INDESIT company

Model type:
AVXD129EX

Commercial code:
F029622

1140960 Exploded views

## n1040306: Reduction of cabinet depth on ARISTON EVOII 6kg washing machines produced at Bre

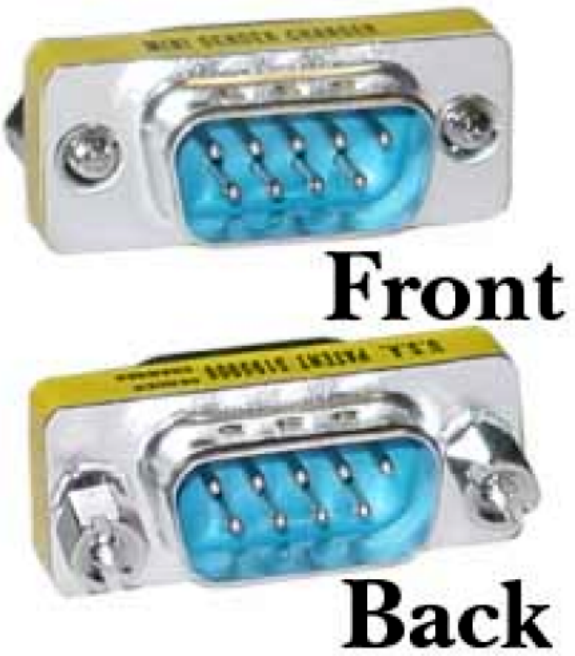
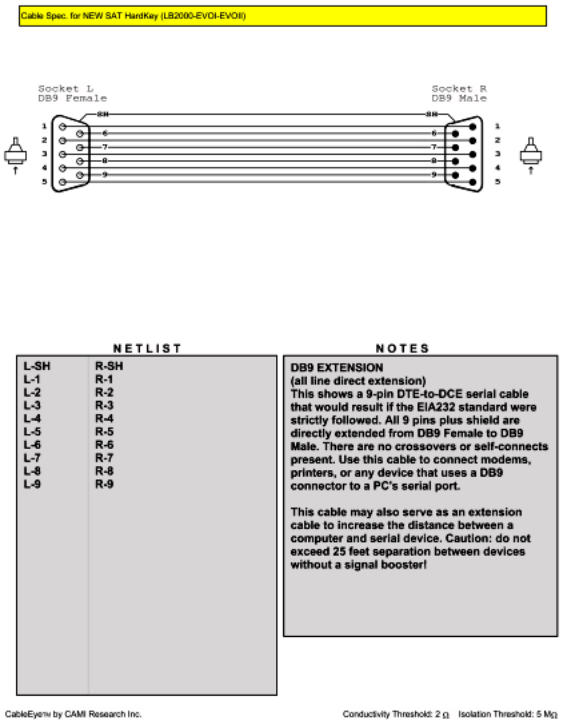
From serial no. 30915.0001, ARISTON EVOII 6kg washing machines affected by this note have been modified due to the reduced depth of the cabinet.
The modified models have a new industrial code.
The items affected by the modification are: cabinet, packing kit, top, product dispenser lid (including solenoid valve) and

solenoid valve.
Regarding the packaging kit, top, product dispenser lid and solenoid valve, the Replacements Warehouse will continue to manage premodification and new parts.
The premodification cabinets will be managed while stocks last, after which, in case of cabinet replacement the new cabinet, top and solenoid valve must be used, referring to the spare parts list for the relevant model.
Given below is a list of models affected by the modification with relevant new and premodification parts:

AVXD109EU (industrial codes: new 91296210001, premodification 91296210000);
AVXD129EX (industrial codes: new 91296220001, premodification 91296220000);
AVXL105EX (industrial codes: new 91296600001, premodification 91296600000);
AVXL109R (industrial codes: new 91297720001, premodification 91297720000);
AVXL89EU (industrial codes: new 91296230001, premodification 91296230000);
AVXD129EU (industrial codes: new 91284980101, premodification 1284980100);
AVXL109EU (industrial codes: new 91296240001, premodification 91296240000);
AVXD125FR (industrial codes: new 91284990101, premodification 91284990100);
AVXL100FR (industrial codes: new 91295430001, premodification 91295430000);
AVXL120FR (industrial codes: new 91295430001, premodification 91295430000);
AVXL88IT (industrial codes: new 91295180001, premodification 91295180000);
AVXL108IT (industrial codes: new 91284970101, premodification 91284970100);
Cabinet: premodification 095747, new 097709;

Packing kit: premodification 095741, new 094777;
Top: premodification 095738, new 097710;
Product dispenser lid (including solenoid valve): premodification 095740, new 097711;
Solenoid valve 1E2U: premodification 095739, new 097712.

AVXL105TK (industrial codes: new 91284830101, premodification 91284830100);
Cabinet: premodification 095747, new 097709;
Packing kit: premodification 095741, new 094777;
Top: premodification 095738, new 097710;
Product dispenser lid (including solenoid valve): premodification 096021, new 097715;
Solenoid valve 1E2U: premodification 095739, new 097712;
Solenoid valve 1E1U: premodification 096022, new 097716.

## n1040381: Drain pump with bayonet-style filter - front Loading Brembate

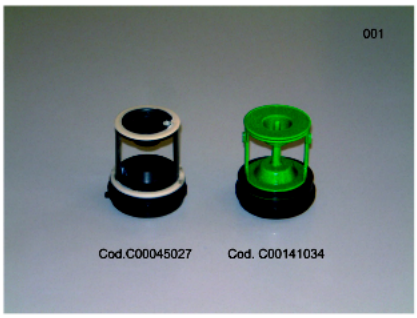
From serial no. 50720.0001 a new drain pump with bayonet-style filter has been installed on all front loading washing machines manufactured in Brembate.

New parts:
C00119307 - Drain pump
C00141034 - Pump filter kit

Premodification parts:
C00092264 - Drain pump
C00045027 - Pump filter kit

The new parts can be used instead of premodification ones.

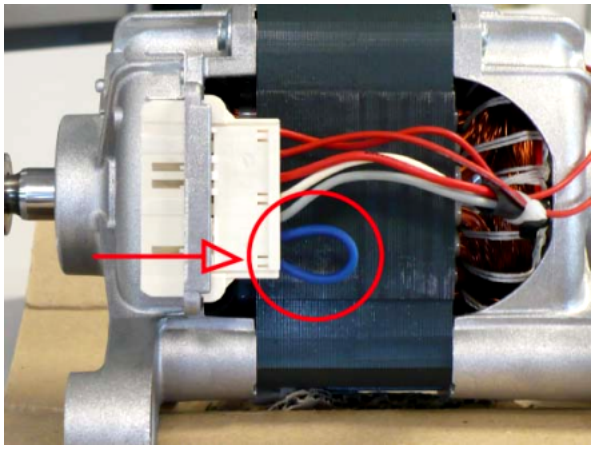
Attention!
When you assist the premodification models using the new motor code you MUST use the thermic link wire code C00265838.

The spare part warehouses will manage the premodification motor until the end of the stock, after they will be replaced with new ones and thermic link wire.

TRIPHASE P40 46 L – INOX TUB
C00265827 new motor without thermic link wire - C00116103 premodification motor with thermic link wire

TRIPHASE P40 46 L – PLASTIC TUB
C00265826 new motor without thermic link wire - C00142390 premodification motor with thermic link wire

TRIPHASE P50 52 L
C00265829 new motor without thermic link wire - C00142205 premodification motor with thermic link wire

TRIPHASE P32 46 L TOP LOADING
C00265832 new motor without thermic link wire - C00262375 premodification motor with thermic link wire

TRIPHASE P40 46 L TOP LOADING
C00265834 nuovo new motor without thermic link wire - C00112739 premodification motor with thermic link wire

In the attached image you can see the fixing of thermic link wire in the motor therminal box.
